Updated - Technical Service Bulletin

SUBJECT: REMEDIAL PROCEDURE TO ADDRESS POSSIBLE OXYGEN LEAKS FROM CONTROL VALVES

BULLETIN NO.: TSB 2018-01 (Revised)

AFFECTED MODEL(S): **BR22 PLUS** EXOTHERMIC CUTTING TORCH

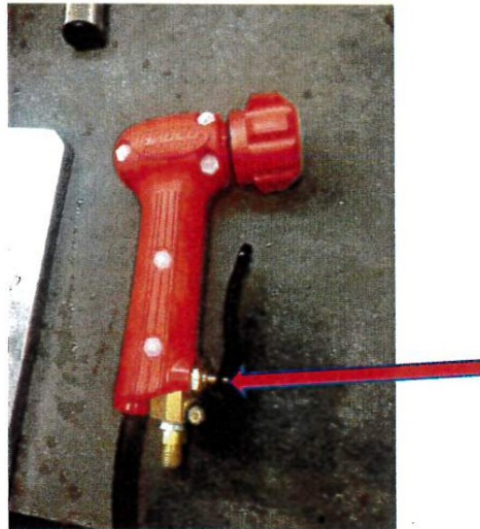
- The picture below shows what a BR22 PLUS torch looks like and the location of the valve stem leak. If this is not what your torch looks like, do not continue!

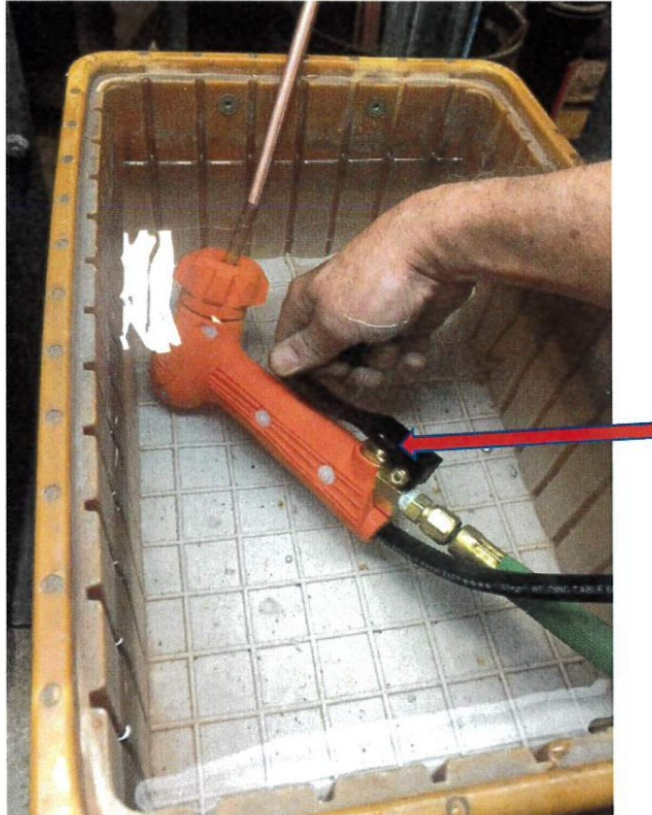
- Outfit the BR22 PLUS torch as shown with an 18" cutting rod inserted and the collet tightened.

- Set oxygen pressure to 180psi (double that of normal operating pressure) and submerge the entire BR22 PLUS torch under water in a suitable container of your choice with the end of the cutting rod raised above the water to exhaust the oxygen gas. Be sure that the valve section is submerged at least 2" below the water surface for clear detection of any possible oxygen leaks.
- Keep the BR22 PLUS submerged for about 30 seconds before carrying out the next steps. You will likely see some bubbles here from air pockets inside the torch body.
- With the end of the rod raised above water, depress the valve lever with a 2 second count and while doing so, inspect the valve stem area (shown in the picture with a red arrow) for any steady stream of bubbles. Repeat this step 5-10 times.

- If the stream of bubbles is present, please remove the BR22 PLUS torch from service and contact Broco-Rankin. If there are no visible leaks, please resume use of the product as intended.
